Proposal for new 03 series of amendments to UN Regulation No. 117 (Tyre rolling resistance, rolling noise and wet grip)

Submitted by the Working Party on Noise and Tyres*

Proposal for new 03 series of amendments to UN Regulation No. 117 (as a basis, the 02 series of amendments including Supplement 14 as contained in ECE/TRANS/WP.29/2022/8)

Example 1

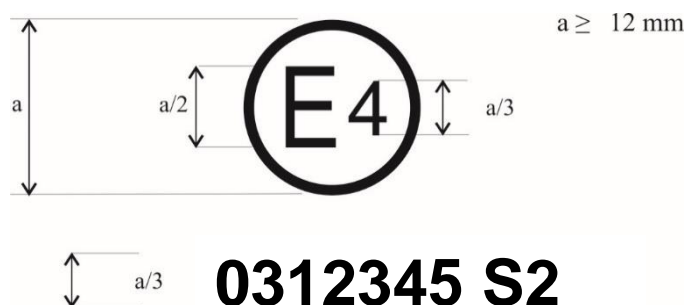
Annex 2, Appendix 1, amend to read:

The above approval mark, affixed to a tyre shows that the tyre concerned has been approved in the Netherlands (E4) pursuant to UN Regulation No. 117 (marked by S2 (rolling sound emission at stage 2)), under approval number 0312345. The first two digits of the approval number (03) indicate that the approval was granted according to the requirements of the 03 series of amendments to this Regulation.

Example 2

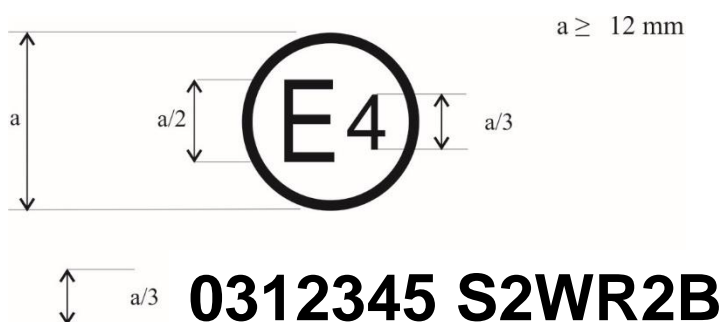
The above approval mark shows that the tyre concerned has been approved in the Netherlands (E4) pursuant to UN Regulation No. 117 (marked by S2 (rolling sound emission at stage 2), W (wet adhesion of tyres in new state), R2 (rolling resistance at stage 2) and B (wet adhesion of tyres in worn state)) under approval number 0312345. The first two digits of the approval number (03) indicate that the approval was granted according to the requirements of the 03 series of amendments to this Regulation."

Example 1

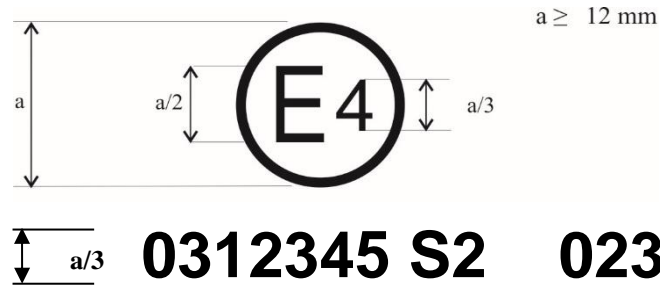
Annex 2, Appendix 2, amend to read:

The above approval mark shows that the tyre concerned has been approved in the Netherlands (E4) pursuant to UN Regulation No. 117 (marked by "S2" (rolling sound emission at stage 2)), under approval number 0312345 and UN Regulation No. 30, under approval number 0236378. The first two digits of the approval numbers ("03" and "02") indicate that the approval pursuant to UN Regulation No. 117 was granted according to the 03 series of amendments and the approval pursuant to UN Regulation No. 30 according to the 02 series of amendments.

Example 2

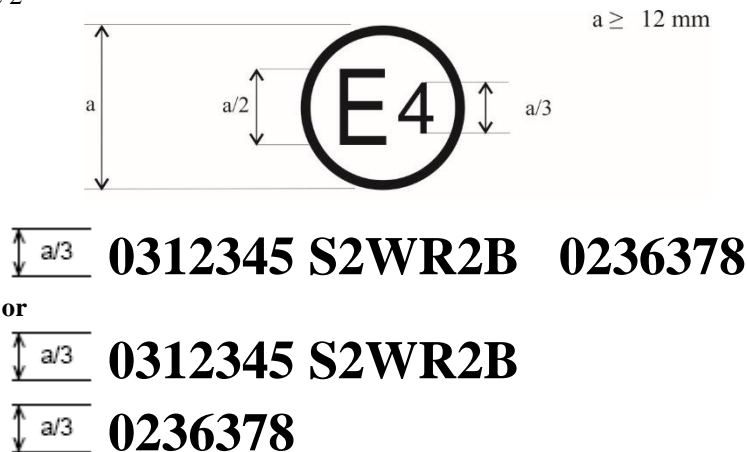
The above approval mark shows that the tyre concerned has been approved in the Netherlands (E4) pursuant to UN Regulation No. 117 (marked by "S2WR2B" (rolling sound emission at stage 2, wet adhesion of tyres in new state, rolling resistance at stage 2 and wet adhesion of tyres in worn state)), under approval number 0312345 and UN Regulation No. 30 under approval number 0236378. The first two digits of the approval numbers ("03" and "02") indicate that the approval pursuant to UN Regulation No. 117 was granted according to the 03 series of amendments and the approval pursuant to UN Regulation No. 30 according to the 02 series of amendments.

Example 3

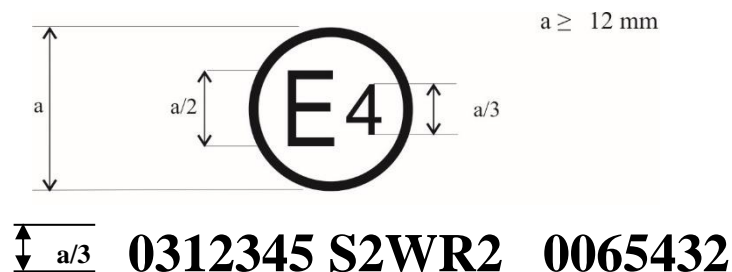
The above approval mark shows that the tyre concerned has been approved in the Netherlands (E4) pursuant to UN Regulation No. 117 (marked by "S2WR2" (rolling sound emission at stage 2, wet adhesion of tyres in new state and rolling resistance at stage 2)), under approval number 0312345 and UN Regulation No. 54 under approval number 0065432. The first two digits of the approval numbers ("03" and "00") indicate that the approval pursuant to UN Regulation No. 117 was granted according to the 03 series of

amendments and the approval pursuant to UN Regulation No. 54 according to its original form."

Example 1

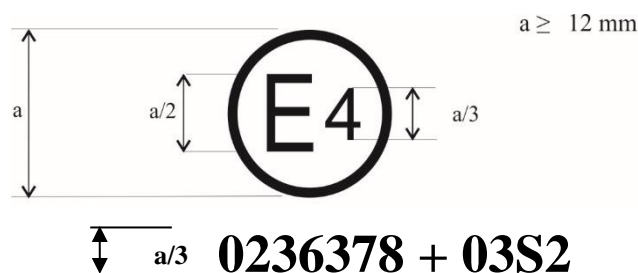
Annex 2, Appendix 3, amend to read:

The above approval mark shows that the tyre concerned has been approved in the Netherlands (E4) pursuant to UN Regulation No. 30 according to its 02 series of amendments (indicated by the first two digits of the approval number, "02") under approval number 0236378. It is also marked by "+ 03S2" which indicates that the tyre was also approved pursuant to UN Regulation No. 117 (03 series of amendments) for S (rolling sound emission at stage 2).

Example 2

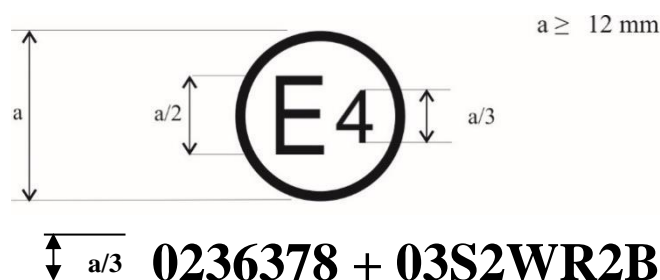
The above approval mark shows that the tyre concerned has been approved in the Netherlands (E4) pursuant to UN Regulation No. 30 according to its 02 series of amendments (indicated by the first two digits of the approval number, "02") under approval number 0236378. It is also marked by "+ 03S2WR2B" which indicates that the tyre was also approved pursuant to UN Regulation No. 117 (03 series of amendments) for S (rolling sound emission at stage 2) W (wet adhesion of tyres in new state), R (rolling resistance at stage 2) and B (wet adhesion of tyres in worn state)."

Example 1

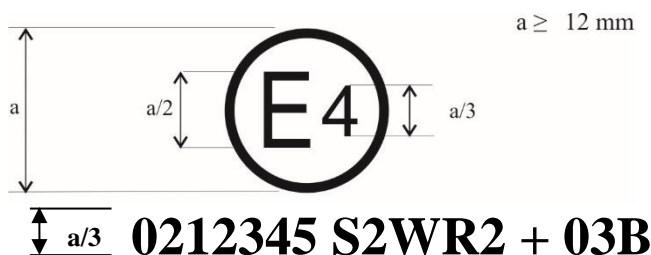
Annex 2, Appendix 4, amend to read:

The above approval mark shows that the tyre concerned has been initially approved in the Netherlands (E4) pursuant to UN Regulation No. 117 and the 02 series of amendments under approval number 0212345. The marking is complemented by S2WR2 (rolling sound emission at stage 2) W (wet adhesion of tyres in new state) and R (rolling resistance at stage 2). The "03B" preceded by "+" indicates that it has had its approval extended under UN Regulation No. 117 and 03 series of amendments to wet adhesion of tyres in worn state based on separate certificate."
